# UNITED STATES PATENT AND TRADEMARK OFFICE

APPLICATION NO.	FILING DATE	FIRST NAMED INVENTOR	ATTORNEY DOCKET NO.	CONFIRMATION NO.
10/709,877	06/02/2004	Kevin P. Pearce		3876

**Office Action Summary**

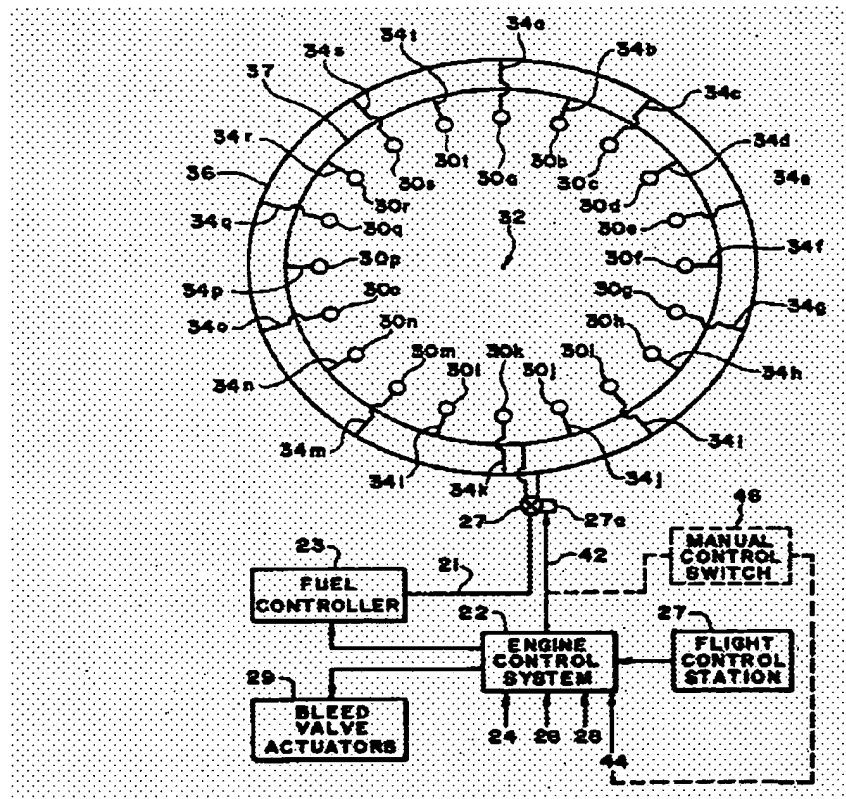
\*Figures 5a and 5b show 4 or 6 independent fuel injectors distributed around the circumference of the combustion chamber (typical arrangement in the art). However, these fuel injector are not grouped\* in any way.

\*According to the Merriam Webster's Collegiate Dictionary, group means two or more elements assembled together or having a unifying relationship. In figures 5a and 5b, two or more fuel injectors are not assembled together or having a unifying relationship. The fuel injectors are independently assembled around the circumference of the combustion chamber, they are not grouped in any way.

As an example of what the examiner is requesting regarding the drawings, refer to the figures of US 5,205,116.

Corrected drawing sheets in compliance with 37 CFR 1.121(d) are required in reply to the Office action to avoid abandonment of the application. Any amended replacement drawing sheet should include all of the figures appearing on the immediate prior version of the sheet, even if only one figure is being amended. The figure or figure number of an amended drawing should not be labeled as "amended." If a drawing figure is to be canceled, the appropriate figure must be removed from the replacement sheet, and where necessary, the remaining figures must be renumbered and appropriate changes made to the brief description of the several views of the drawings for consistency. Additional replacement sheets may be necessary to show the renumbering of the remaining figures. Each drawing sheet submitted after the filing date of an application must be labeled in the top margin as either "Replacement Sheet" or "New Sheet" pursuant to 37 CFR 1.121(d). If the changes are not accepted by the examiner, the applicant will be notified and informed of any required corrective action in the next Office action. The objection to the drawings will not be held in abeyance.

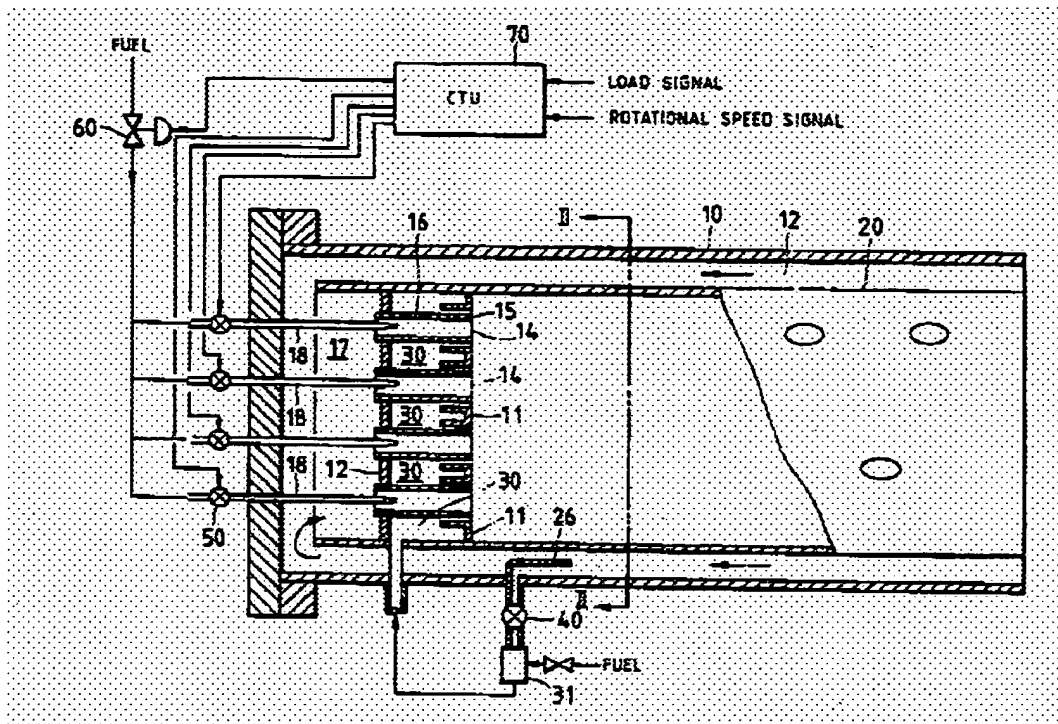
signals to the value of a desired signal, and for generating fuel injector control signals to said plurality of fuel injectors, and means for directing the fuel injectors control signals to said plurality of fuel injectors. See particularly **Figures 1, 3**.

As clearly shown in Figure 3 of Ng, the programmable electronic control unit 22 receives sensor signals 24, 26, 28 from sensors detecting operational parameters (i.e., load, speed, temperature, etc, see cl.3 ll.48-54) of the turbine engine. Then, these sensor signals received from the sensors are compared to their desired values. Based on the difference the controller sends a signal to the fuel controller 23 to adjust the fuel injection through the fuel injectors accordingly. Ng's fuel injectors are arranged as the ones disclosed and claimed in the invention. See particularly **Figures 1, 3**.
